SITE DEVELOPMENT PLAN - PHASE I  
 CLARKSBURG VILLAGE  
 CLARKSBURG (2ND) ELECTION DISTRICT  
 MONTGOMERY COUNTY, MARYLAND

**SUBJECT:** Final Water Quality Plan for Clarksburg Village – Site Plan # 8-03002

Re: Final Water Quality Plan for Clarksburg Village-  
Phase I  
SM File #: 200006  
Preliminary Plan No.: 1-01030  
Tract Size, Zone: 333 Ac., R-200/TDR-4,  
R-200/TDR-3, R-200 and PD-4  
Tax Plate: EW, EV, FV 123 and FV 122  
Watershed: Little Seneca Creek

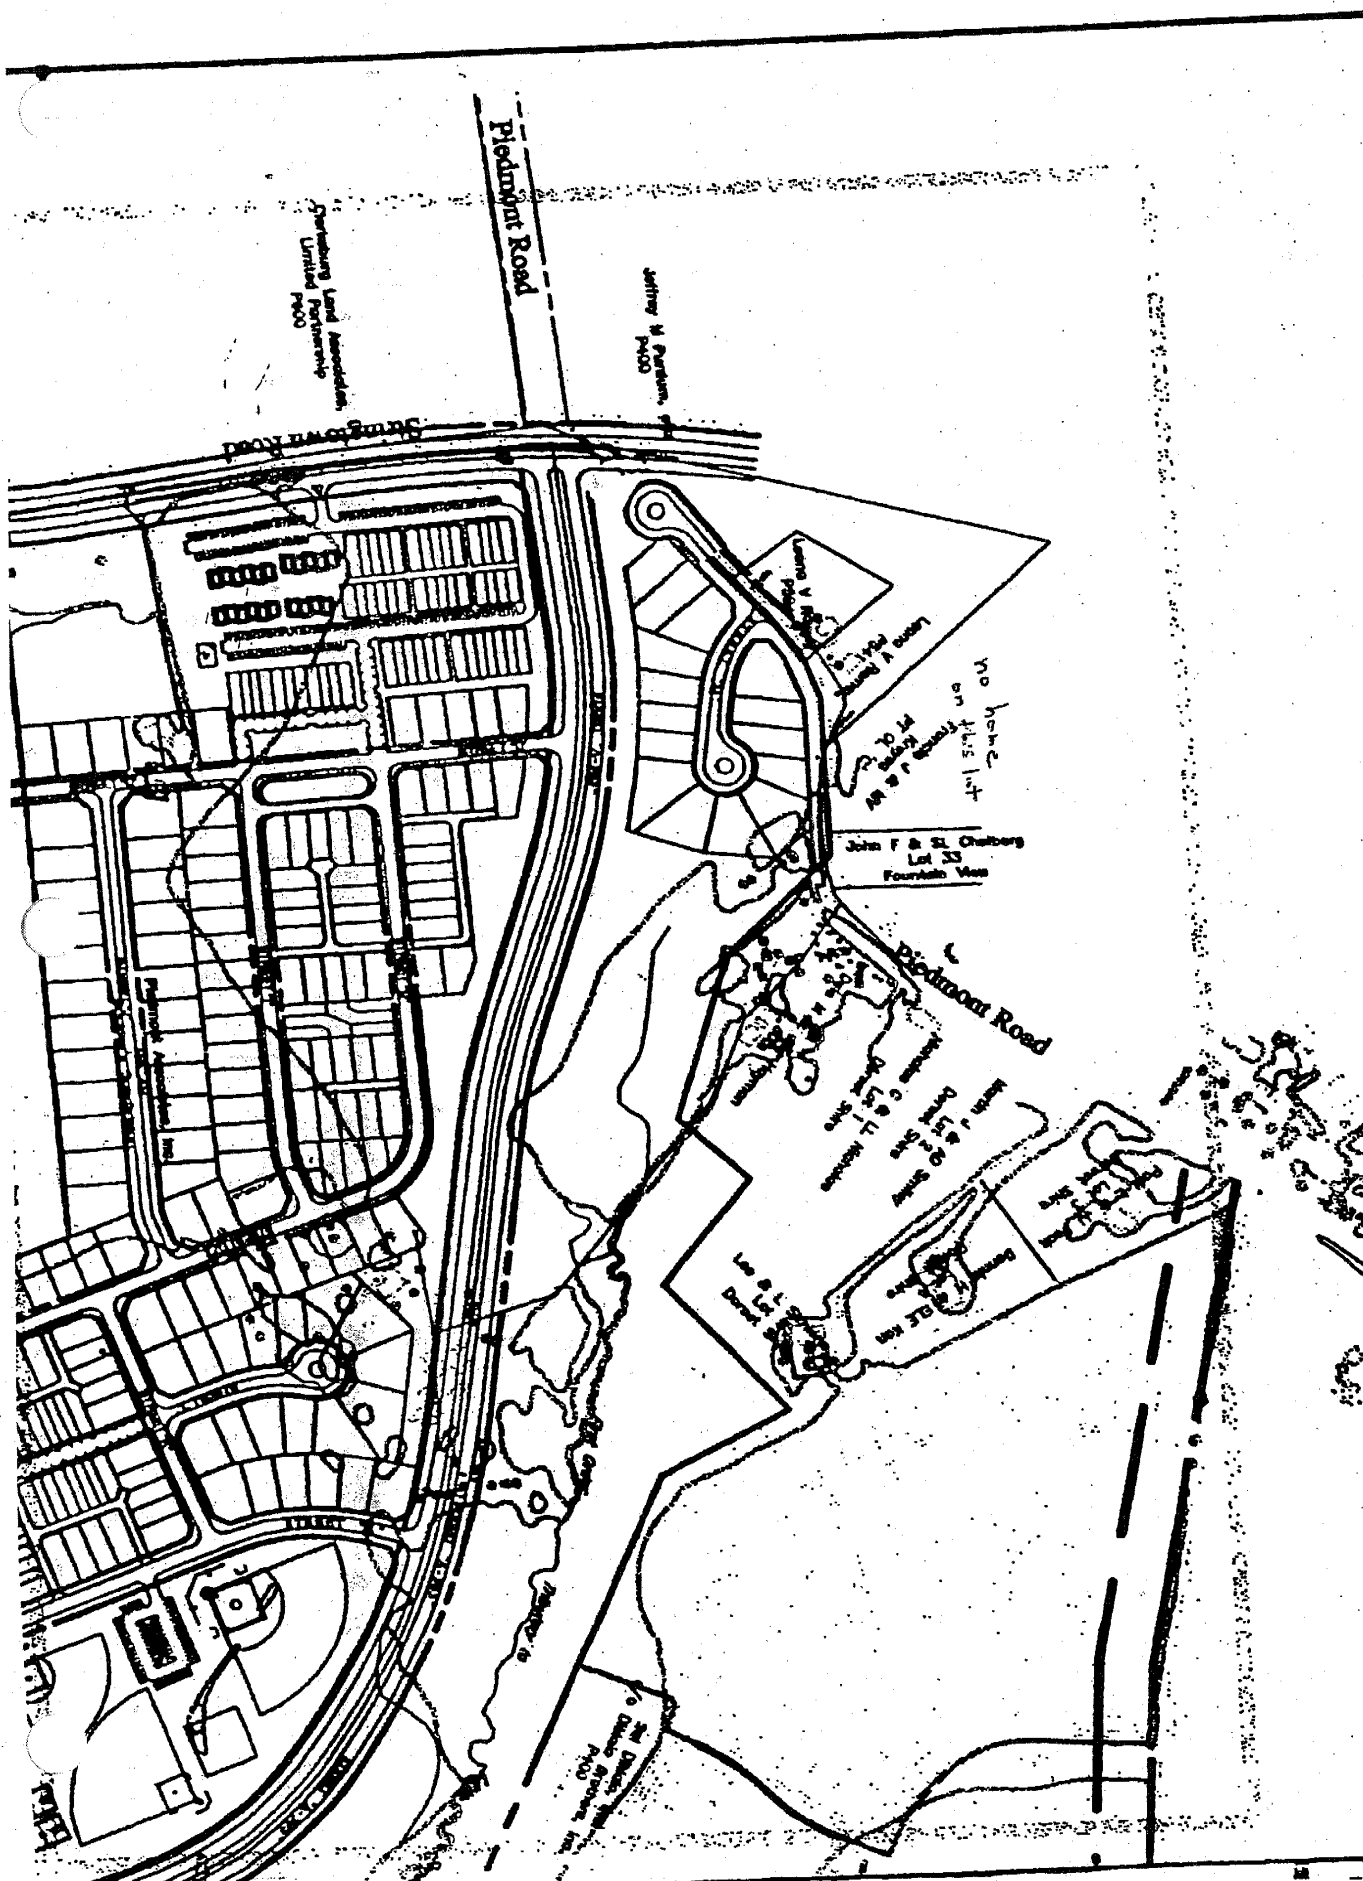
We the undersigned Piedmont Road property homeowners, would like to see the section of Piedmont Road referenced in the attached drawing end in a court and not connect to A-305. As Piedmont Road has been designated a rural, rustic road, we feel having the road end in a court rather than attached to a major arterial road would better preserve its existing character, thereby allowing it to remain in keeping with the intent of the rural designation.

We have attached a copy of Mr. Flanagan's preliminary site plan for our section of Piedmont Road with the end of Piedmont changed to a court. This concept represents our vision for Piedmont Road.

We are writing in reply to your letter/petition received on September 18, 2001 suggesting that the section of Piedmont Road, a rustic road, approaching Stringtown Road and proposed A-305 end in a cul-de-sac, and not connect to either road.

Planning staff involved in Community-Based Planning, Subdivision Development Review, Site Plan Review, as well as Transportation Planning have reviewed your request. It is staff's consensus that the connection of Piedmont Road to A-305 as approved in the preliminary plan for Clarksburg Village is essential to provide connectivity of local neighborhoods and to provide opportunities for local circulation of vehicular and pedestrian traffic within the community. Therefore, staff does not support your idea to terminate Piedmont Road in a cul-de-sac approaching Stringtown Road or A-305.
